Information for DOE-NRC Discussions
NRC Request for Additional Information
SRS Tank 19 and Tank 18 Section 3116 Draft Waste Determination

CBU-PIT-2006-00106
June 6, 2006

Draft 3116 Waste Determination for Closure of Tank 19 and Tank 18

For DOE-NRC Discussions Related to Performance Assessment

Comment 4 – Tank 19 structural steel (1)

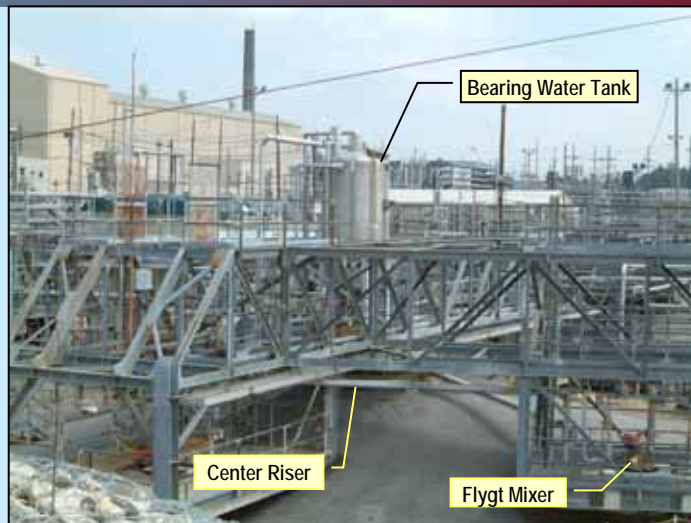
Basic path forward recommended by NRC: Provide additional information on 6 matters related to waste removal technology selection.

Proposed DOE approach: Provide the requested information with supporting details.

- Available tank risers were used to the best advantage in waste retrieval
- *Line of sight* refers to area of tank interior visible from opening without camera
- Creating new tank openings entails risk to tank structural integrity
- Tank 19 center riser plugs could not be removed due to interferences
 - However, structural evaluation was performed and it was determined to be acceptable to drill small holes in center riser plug
- Substantial personnel radiation exposure (total person-rem) would be involved with removal of equipment presently installed in Tanks 19 and 18

Photo of Tank 19 Floor Lifting Plate

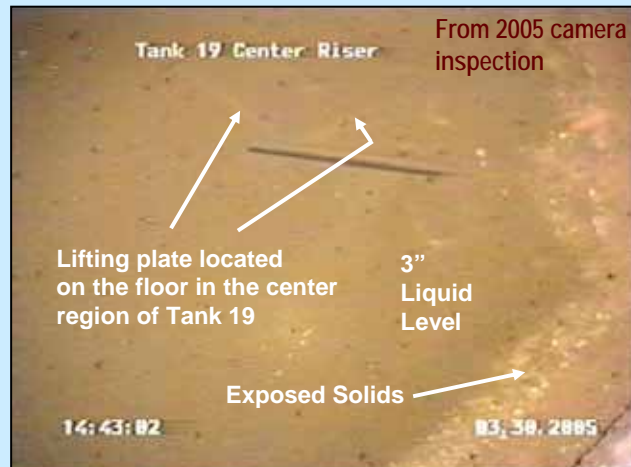
Basic path forward recommended by NRC: Provide solid sample details, including samples taken in residual hardened material in both tanks, or increase tank inventories to account for uncertainty

Proposed DOE approach: Provide information to demonstrate there are no hidden zeolite slabs in Tank 19 and that contents of both tanks are well mixed.

- Tank 19
 - (1) All zeolite discharged directly under NE riser; (2) hydrolance broke up zeolite slabs under this riser, with 11 detailed inspections showing no zeolite slabs elsewhere in tank (see next slide); (3) heel maps show significant redistribution of residual solids; (4) simulant testing showed mixer effectively cleaned tank bottom; and (5) velocity profile test results
- Tank 18
 - (1) South mound sample results were carefully considered in inventory development and (2) alternative method separately characterizing south mound material produced only negligibly different inventory (see figures)

Comment 22 – GSA groundwater flow

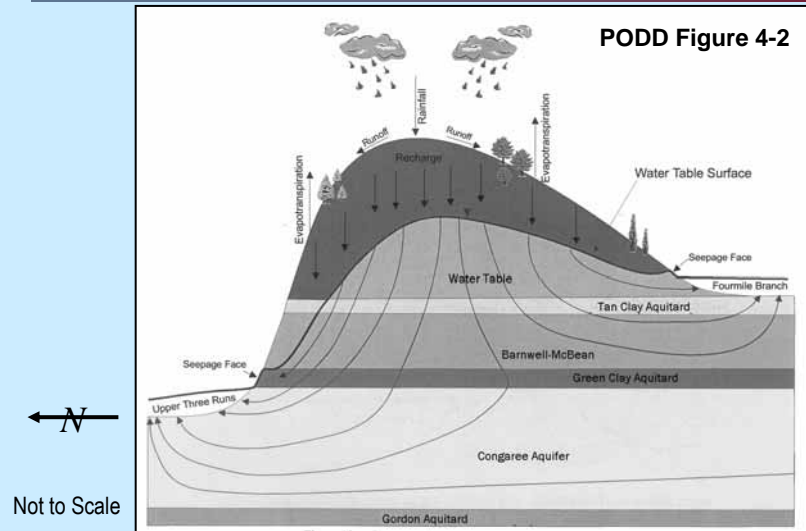
Basic path forward recommended by NRC: Provide data showing all aquifer flow discharges to the streams or demonstrate that the seepage receptor receives higher dose than would a receptor using groundwater at an offsite location, assuming underflow.

Proposed DOE approach: Provide information demonstrating that all aquifer flow discharges to the streams.

- The water table is higher on either side of Fourmile Branch, confirming no underflow
- Potentiometric data for Barnwell-McBean aquifer on both sides of stream indicate flow toward Fourmile Branch
- Groundwater flow maps from semiannual Corrective Action Reports show that Upper Three Runs and Fourmile Branch bound GSA groundwater flow (see figures)
- Large scale integrated groundwater modeling of the GSA confirms this conclusion

Comment 25 (receptor description)

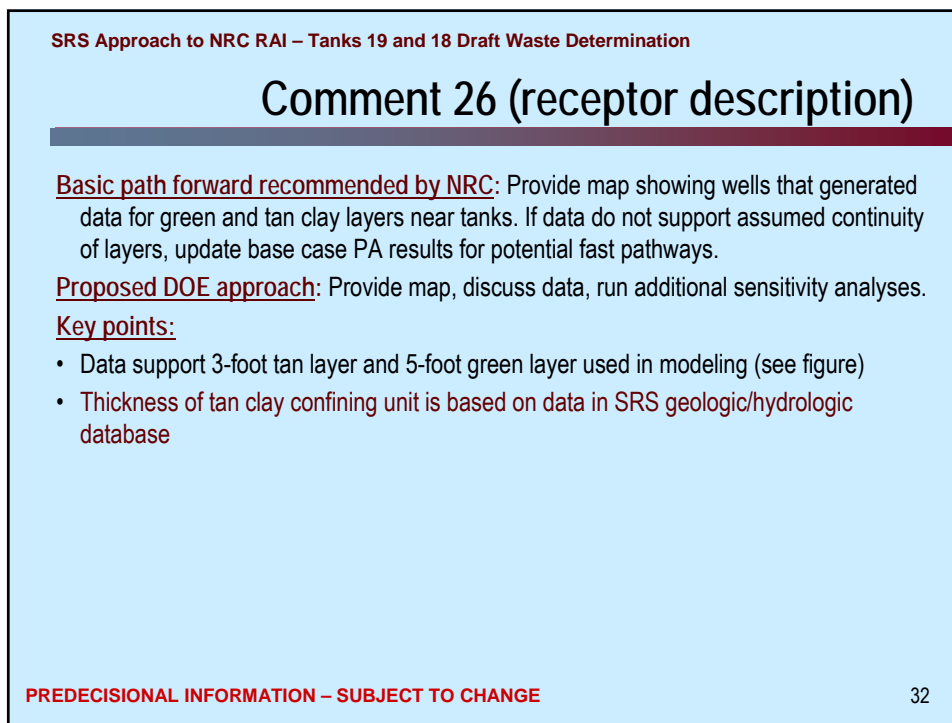
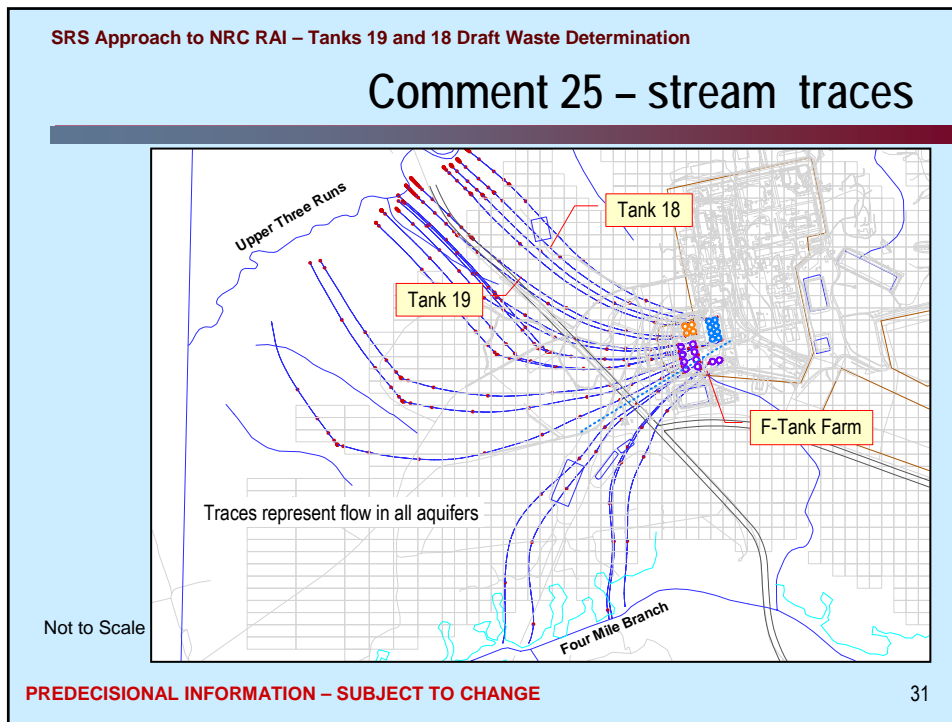
Basic path forward recommended by NRC: Provide information about relative amounts of contaminated infiltration water that flow toward Fourmile Branch and Upper Three runs for each aquifer.

Proposed DOE approach: Provide requested information (see also Comment 21).

- Stream tracer runs based on GSA groundwater flow model (see figure) show that leakage from Tanks 19 and 18 will move toward Upper Three Runs
- 31%/65%/4% balance in Q-CLC-H-00005 based on calibrated model and area closest to the groundwater flow path to Fourmile Branch
- Modeling groundwater flow toward Fourmile Branch is conservative
 - Modeling flow toward Fourmile Branch effectively concentrates contaminants in the upper aquifers, making higher concentrations available for seepage exposures
 - Lower Fourmile Branch flow rate (<10% of Upper Three Runs) means less dilution (and more conservatism) in Fourmile Branch model
 - Permits modeling all 22 FTF tanks on single centerline to Fourmile Branch

Comment 34 (near field release)

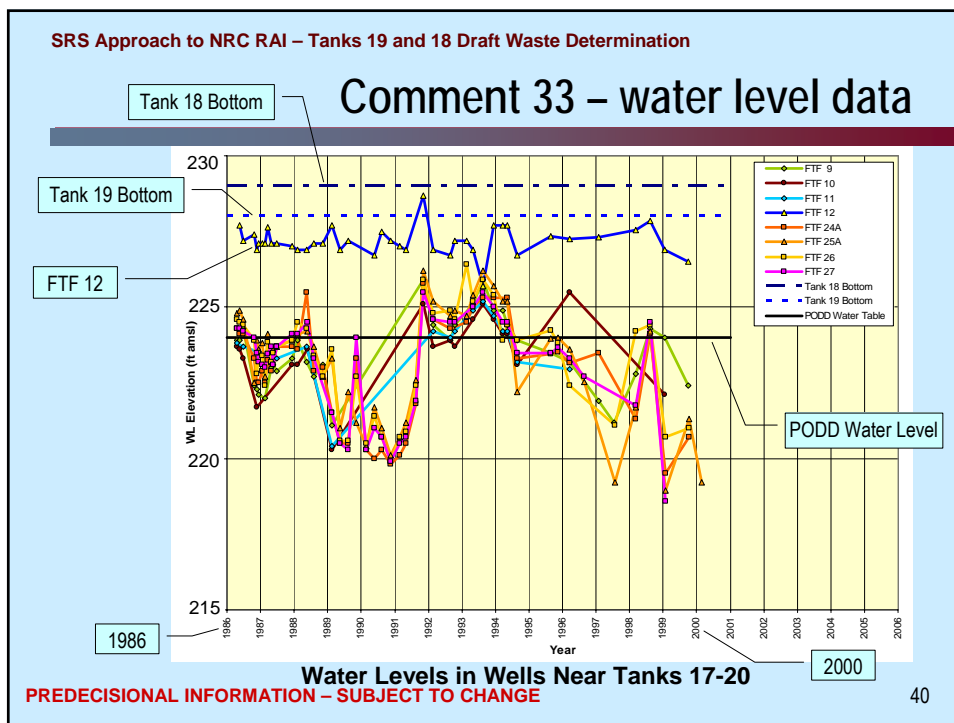
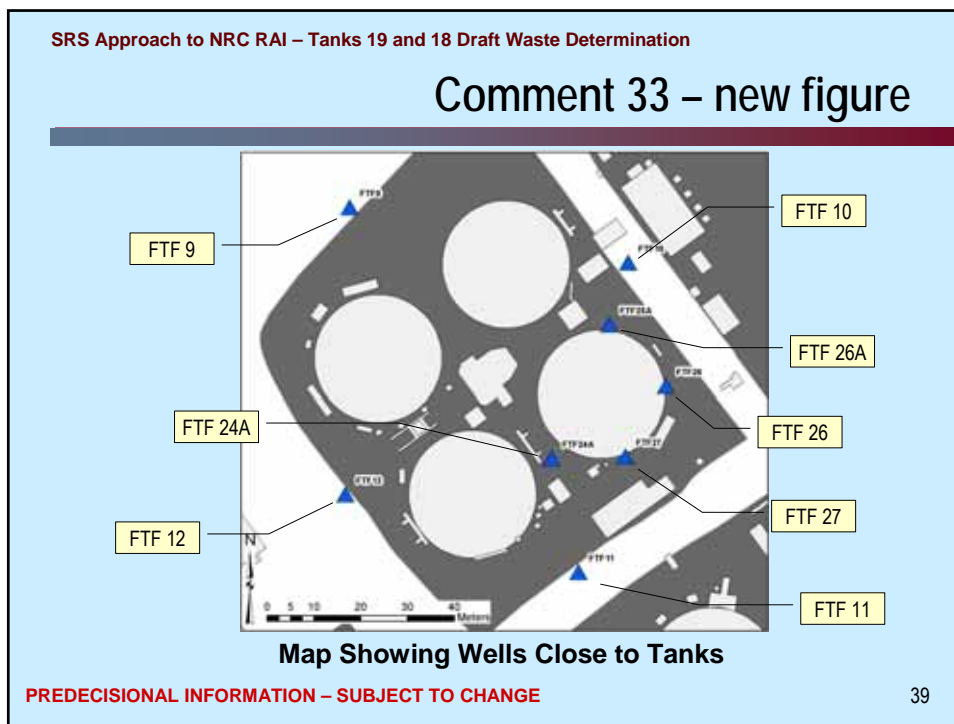
Basic path forward recommended by NRC: Provide all F-Tank Farm water level data and other information on water table depth at tanks. Assess impacts with tank bottoms in water table to inadvertent intruder and member of the public.

Proposed DOE approach: Provide requested information.

- New map shows wells close to tanks (see figure)
- Well data being provided includes up to year 2000
- Historical data show long-term average below base case of 224 feet above mean seal level
- NUREG-1573 indicates that long-term climate changes not to be considered
- Additional sensitivity analyses are being performed
 - Results are to be provided
- Statistical projection was not developed because sensitivity analyses will bound potential conditions

Comment 46 – new figure (1)

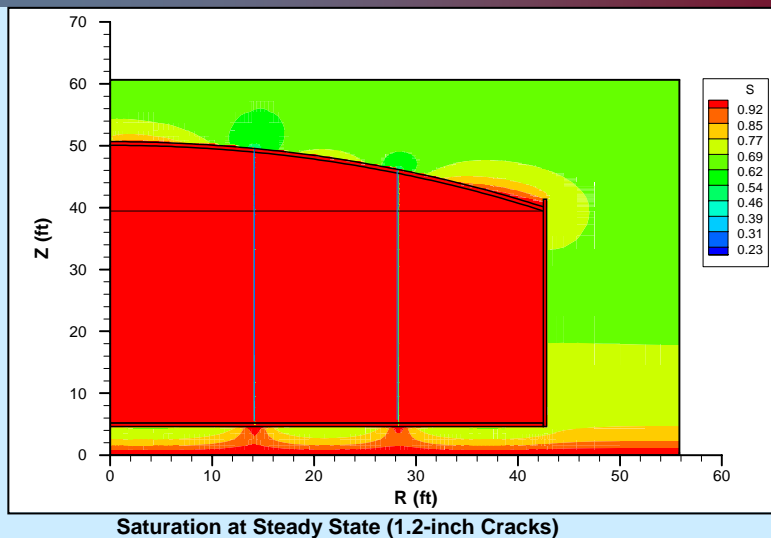
Basic path forward recommended by NRC: Provide basis for assumption that cracks in grout would remain saturated or update extent of oxidation. Provide basis for estimating or bounding impact of grout oxidation on Tc-99 release during 10,000 year period.

Proposed DOE approach: Provide requested information.

- In model associated with PODD Figure 2-35, simulated annular cracks were actually unsaturated (note blue lines in figure)
- Transport model considered only liquid-phase oxygen transport, under-predicting oxygen concentrations, but this model is appropriate because oxygen concentration at grout boundaries would be at saturation for practical purposes
 - Liquid phase diffusion within grout dominates, so including gas phase would not significantly alter slag reduction capacity
- Over time, grout will become saturated by drawing water from surrounding soil

Typical Type IV Waste Tank

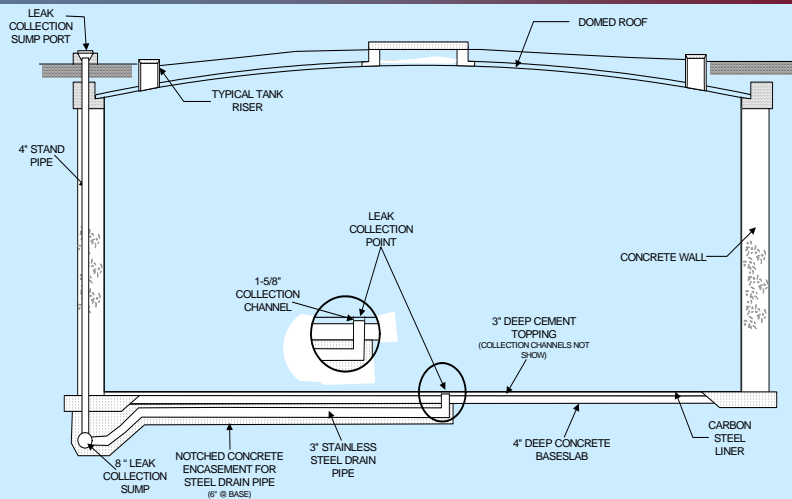
Basic path forward recommended by NRC: Provide data to show basemats are intact, or assess impact of current cracks on public and intruder doses. Provide basemat design details, describing expected effects of drainage slots on basemats.

Proposed DOE approach: Provide requested information.

Comment 50 (far field release)

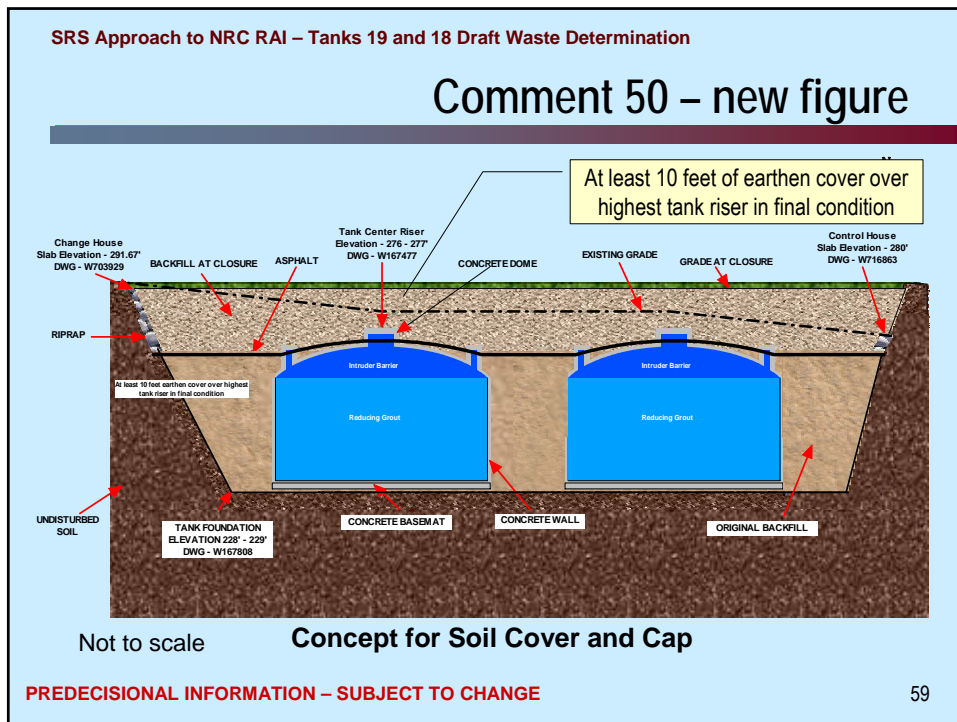
Basic path forward recommended by NRC: Provide basis for (1) hydraulic conductivity of disturbed soil being the same as for undisturbed soil and (2) that riprap layers will not result in high long-term infiltration to the tanks.

Proposed DOE approach: Provide the requested information.

- Soil of interest under tank was undisturbed until basemat and wall foundation were poured; therefore, use of undisturbed values is reasonable
- The riprap and disturbed soil around and above the tank are not associated with MEPAS soil input parameters
 - Significant conservatism comes from ignoring the effect of the earthen cover and low-permeability barrier on infiltration rate
- The sensitivity study on the 40 cm/yr infiltration rate will show the effect of doubling the infiltration rate on peak Tc-99 dose for both tanks
 - Bounds possible effect of riprap channeling flow toward tanks

Comment 51 (model implementation)

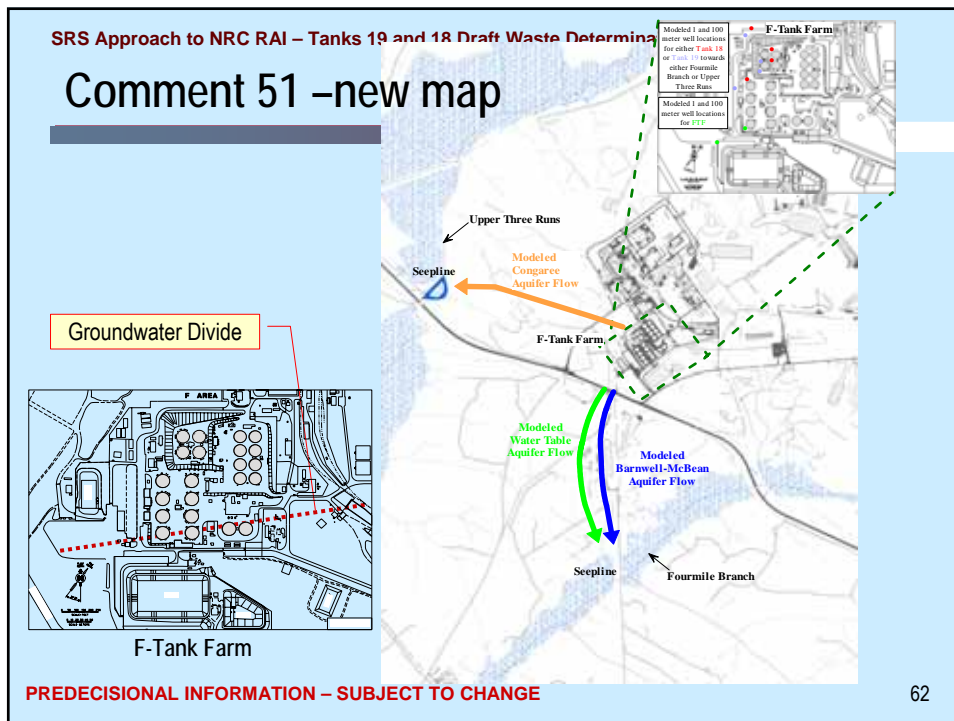
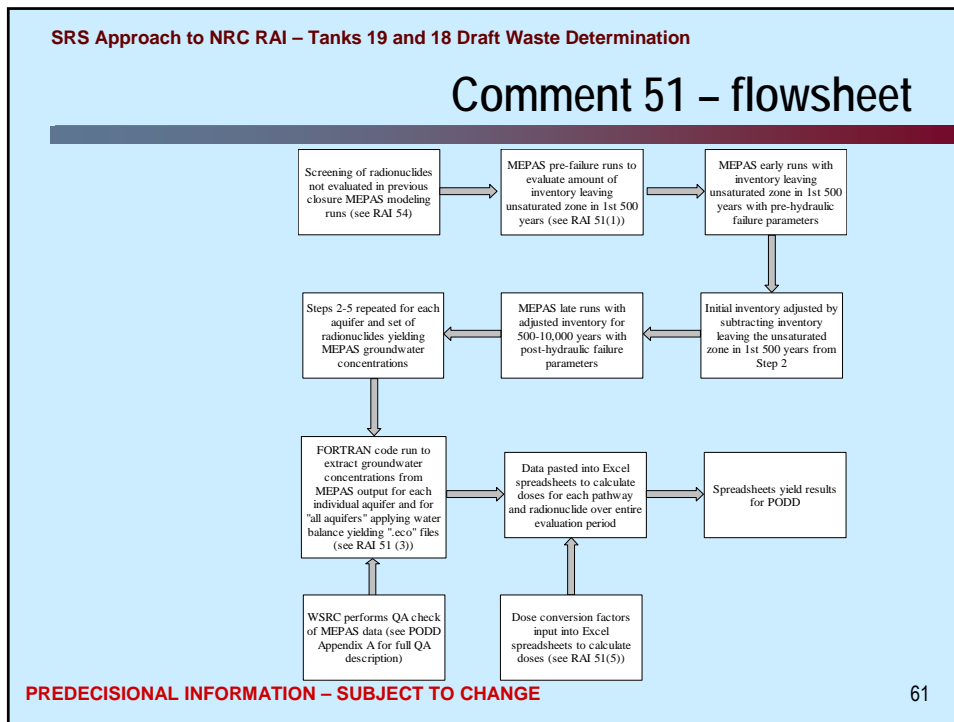
Basic path forward recommended by NRC: Provide detailed information to clarify the overall computational approach, provide MEPAS files for dose conversion factor calculations, and provide a map with all receptor locations and other details.

Proposed DOE approach: Provide requested information.

- All of the requested information is being provided, including addressing each of the 7 areas listed in the Comment BASIS:
 - 1) MEPAS calculation mechanics, including why code was run 3 times
 - 2) Algorithm used in early MEPAS runs
 - 3) FORTRAN program functions
 - 4) How aquifer water balance percentages were included
 - 5) How pathway dose conversion factors were calculated
 - 6) Pathways included in and excluded from Table 4-15 thru 4-35 calculations
 - 7) Distances used from tanks to seepage receptor
